Your ref
APP/20/00443

Our ref
PLAN-034175

Proposal: Single story rear extension.

Site: APP/20/00443: - 5 Tichborne Grove, Havant, PO9 4QG.

Southern Water MapGuide Browser

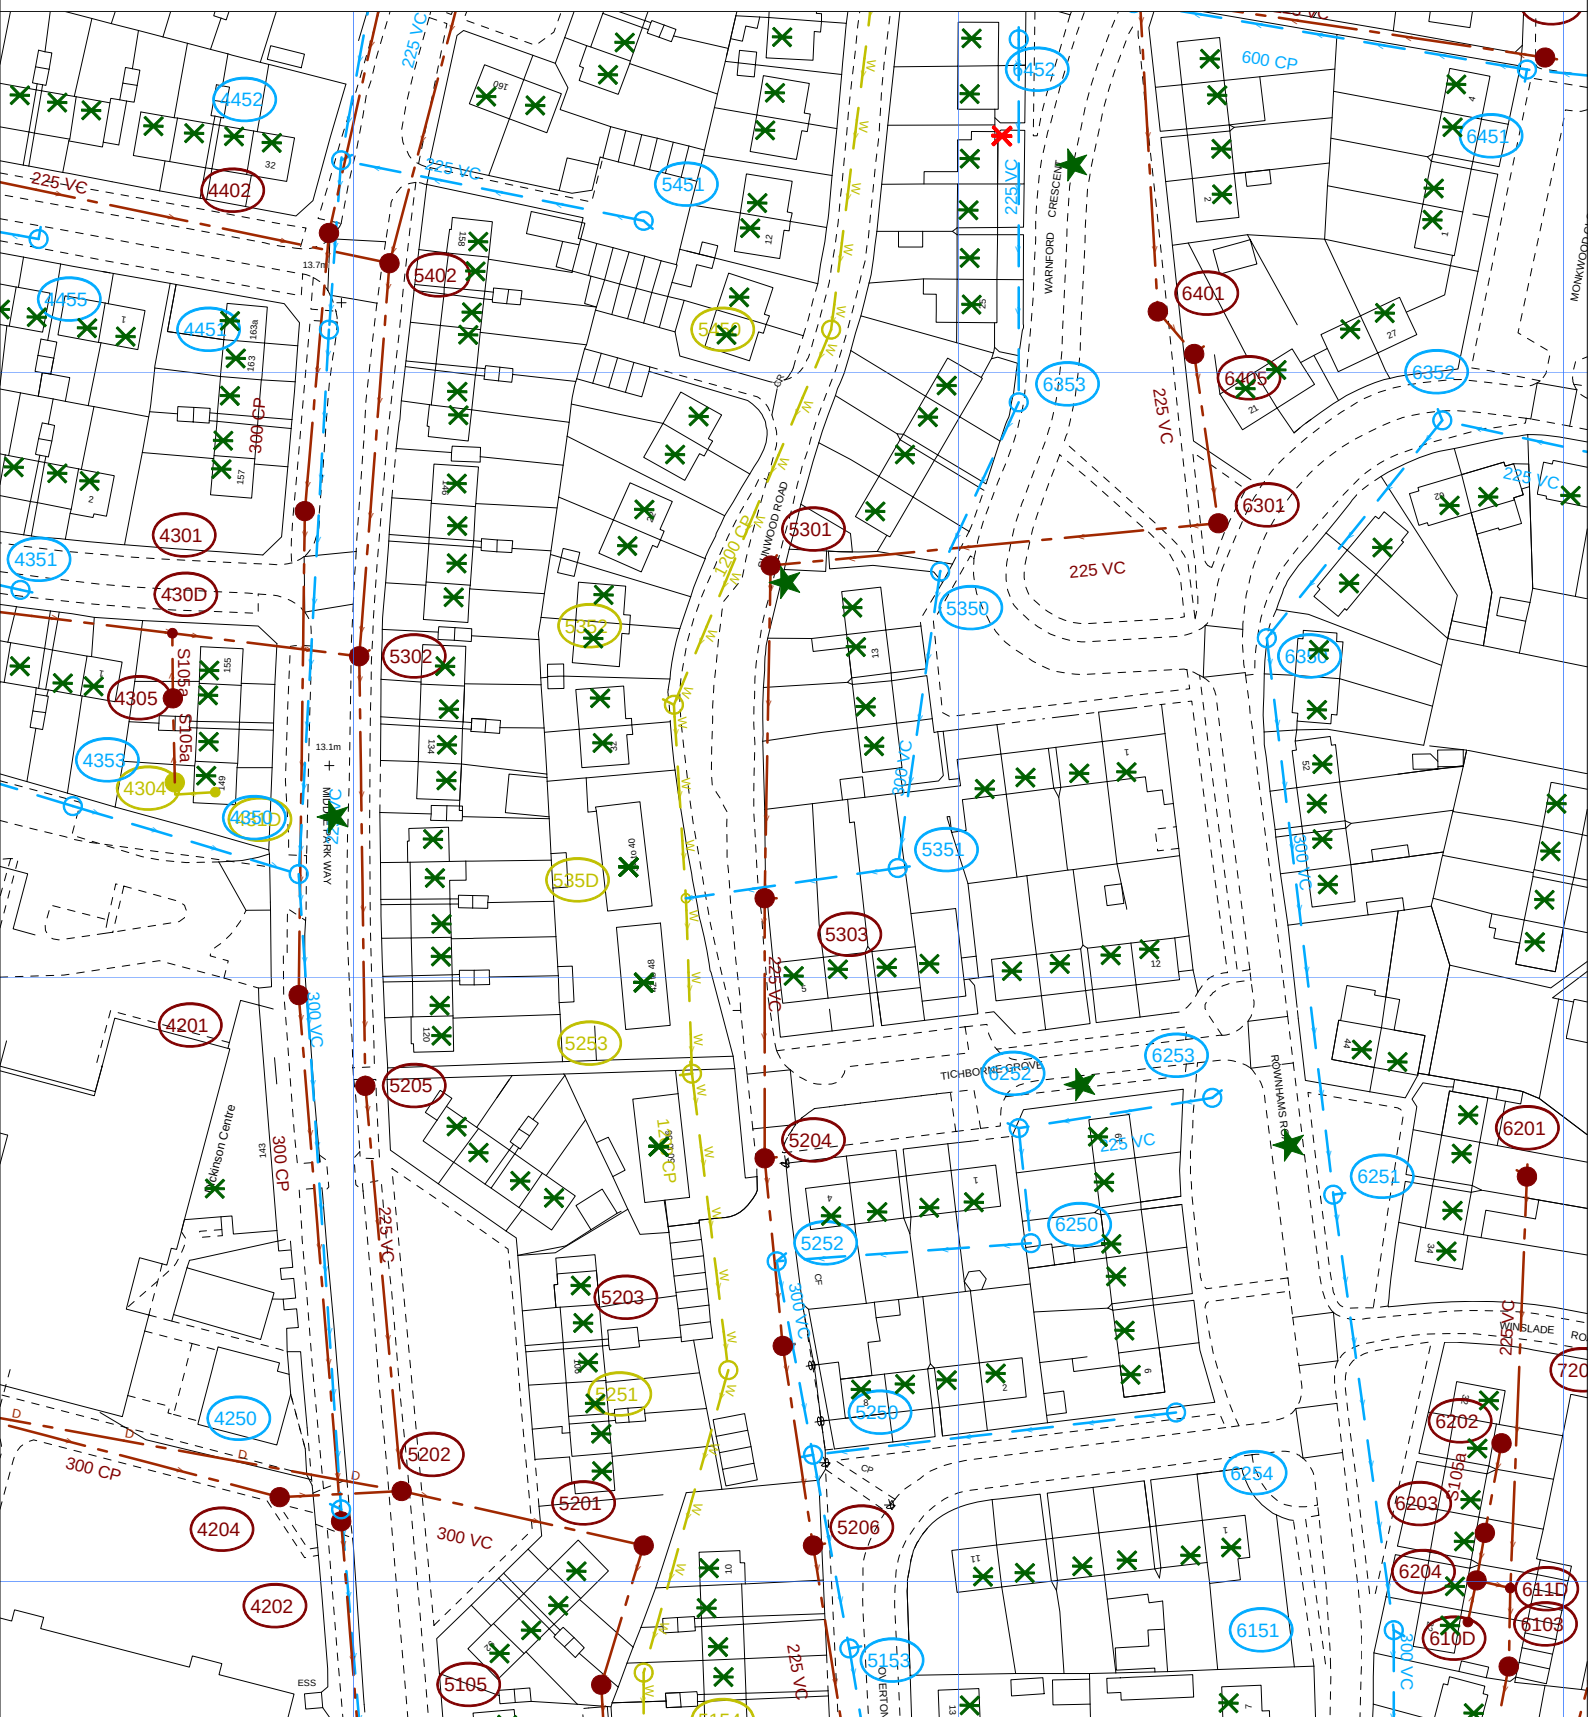
Please find attached a plan of the sewer records showing the approximate position of public foul and surface water sewers within the site. The exact position of the public sewers must be determined on site by the applicant before the layout of the proposed development is finalised.

- The 150mm public foul sewer and 300mm public surface water sewer requires a clearance of 3 metres on either side of the gravity sewers to protect it from construction works and to allow for future access for maintenance.
- No development or tree planting should be carried out within 3 metres of the external edge of the public gravity sewers without consent from Southern Water.
- No soakaway, swales, ponds, watercourses or any other surface water retaining or conveying features should be located within 5 metres of a public sewer.
- All existing infrastructure should be protected during the course of construction works.

Furthermore, it is possible that a sewer now deemed to be public could be crossing the development site. Therefore, should any sewer be found during construction works, an investigation of the sewer will be required to ascertain its ownership before any further works commence on site.
